IN THE SUPREME COURT OF THE STATE OF NEVADA

**JOINT APPENDIX**

**Rebuttal to Order 1303 Reports  
Submitted to the Nevada State Engineer**

Prepared by:  
Stetson Engineers Inc.  
785 Grand Ave  
Suite 202,  
Carlsbad, CA 92008

**FIGURE 1. MRSA AVERAGE MONTHLY GROUNDWATER PRODUCTION AS PERCENT OF ANNUAL, 1998-2018**

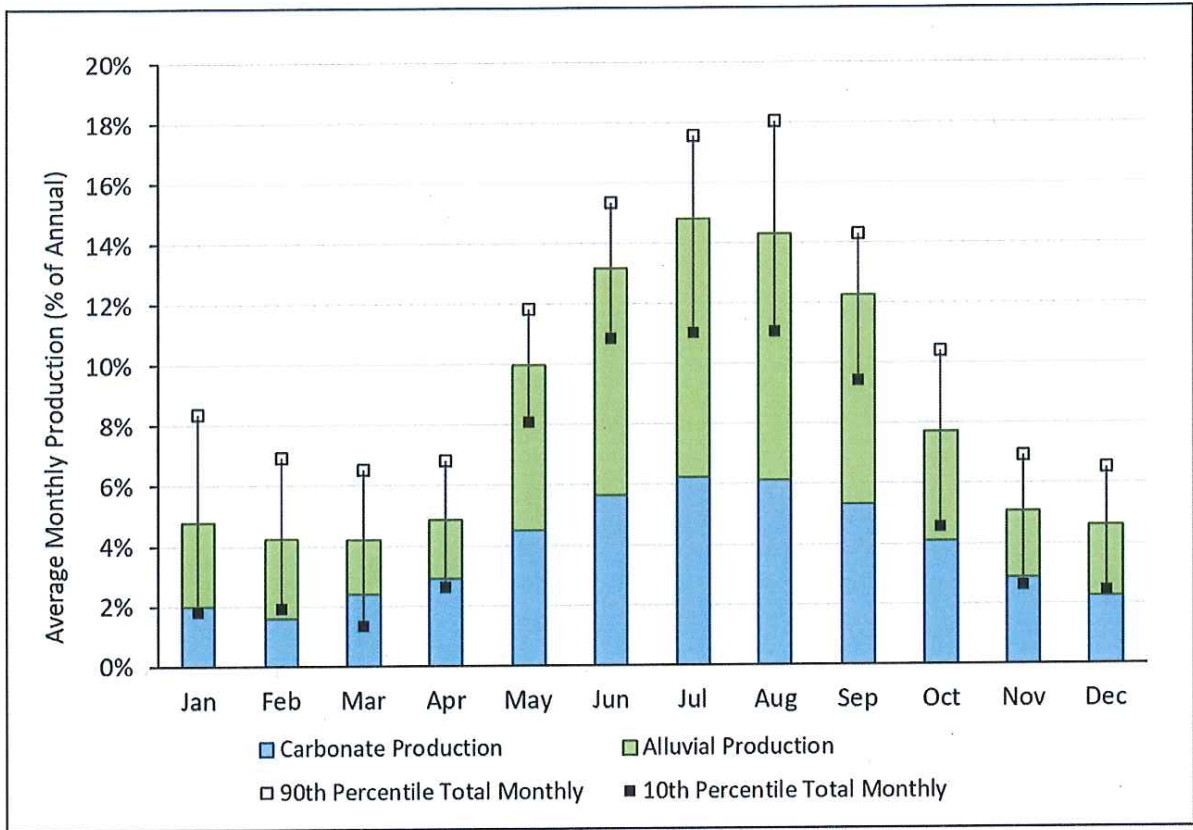
Groundwater pumping in the southwestern United States is generally greatest during the summer months and least during the winter. The average monthly groundwater production in the MRSA from 1998 to 2018 is shown in Figure 1 as a percentage of annual production. This data indicates that peak groundwater production occurs in July, and minimum production occurs in February (Figure 1). Maximum groundwater levels would occur in response to minimum pumping. Conversely, minimum groundwater levels would occur in response to maximum groundwater pumping. Therefore, based on actual groundwater production in the MRSA, maximum groundwater levels would occur during February and March and minimum groundwater levels would occur in late summer.

**FIGURE 2. GRAPHICAL REPRESENTATION OF SNWA REPORT TABLE 6-2 SHOWING RELATIONSHIP BETWEEN WARM SPRINGS WEST AND MRSA DISCHARGE**

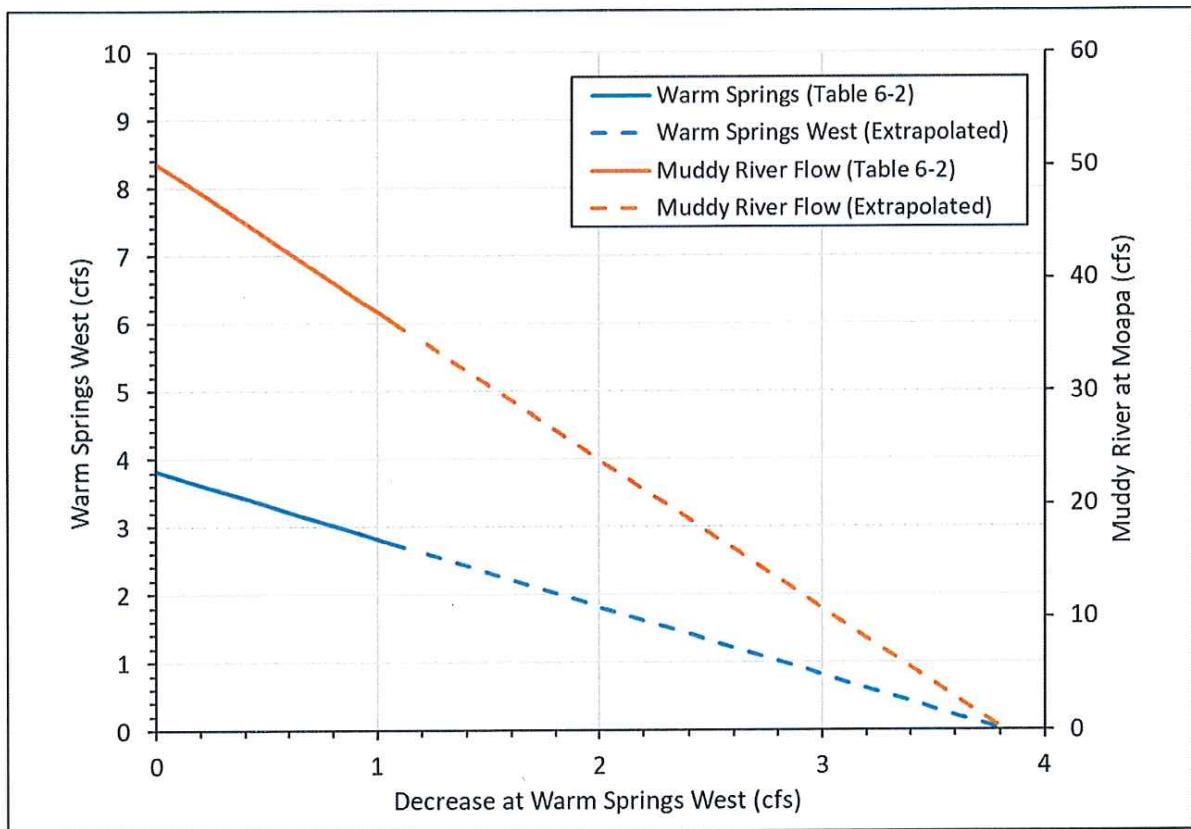
Report that suggests a 6,000 AFY reduction in predevelopment MRSA discharge would occur when Warm Springs West drops to 3.2 cfs is graphically depicted in Figure 2. The solid line represents the streamflow reduction presented in Table 6-2 of the SNWA Report, while the dashed line represents a continuation of their data based on their stated assumption that their ratio is sound as long as all seeps and springs continue to flow. As shown in the figure, their assumption would suggest that as groundwater levels drop below 1,771 feet, resulting in 0 cfs at Warm Springs West, the Muddy River near Moapa at 1,710 feet would cease to flow. Based on contributions of flow from the alluvium and lower elevation seeps, it is not likely that the Muddy River would cease to flow. Therefore, reductions in Muddy River flow should not be estimated based only on changes in flow at Warm Springs West.
